Countries: CANADA, UNITED STATES Document ID: IK1201440
 Availability: ISIS, FleetISIS, IsSIR Revision: 0
 Major System: ENGINES Created: 8/25/2019
 Current Language: English Last Modified: 8/27/2019
 Other Languages: NONE Author: Greg Scheff
 Viewed: 54

Title: A26 Fuel Delivery Pressure Sensor (FDP) and Harness Pigtail Eliminated

Applies To: All A26 Engines

Figure #1: Engine Mounted Fuel Filter Housing

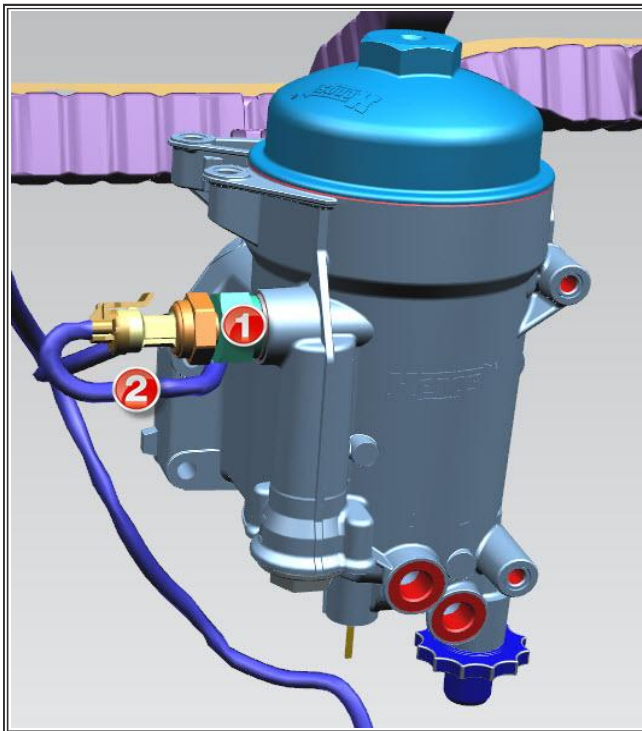
This document will explain the removal of the fuel delivery pressure sensor and harness pigtail on the A26 engine. The early built A26 engines had the fuel delivery pressure sensor installed in the engine mounted fuel filter housing (Figure #1) however, the ECM never monitored the signal from it. Later the sensor was removed, the port was plugged, and the engine harness was modified to remove the pigtail and the connector for it.

Questions from the field have come up while installing a replacement engine harness. Some of the C92 engine harnesses may come through parts when you are replacing a harness on an engine that does not have a FDP sensor installed.

IT IS ACCEPTABLE to install a C92 harness on a newer engine not equipped with the FDP sensor.

- The unused pigtail (Figure #1 item 2) and connector for the FDP sensor can simply be tied off and tucked out of the way OR
- The pigtail (Figure #1 item 2) can be cut off, and apply heat shrink tubing at the wire ends
- The wiring for those circuits to the ECM are not used
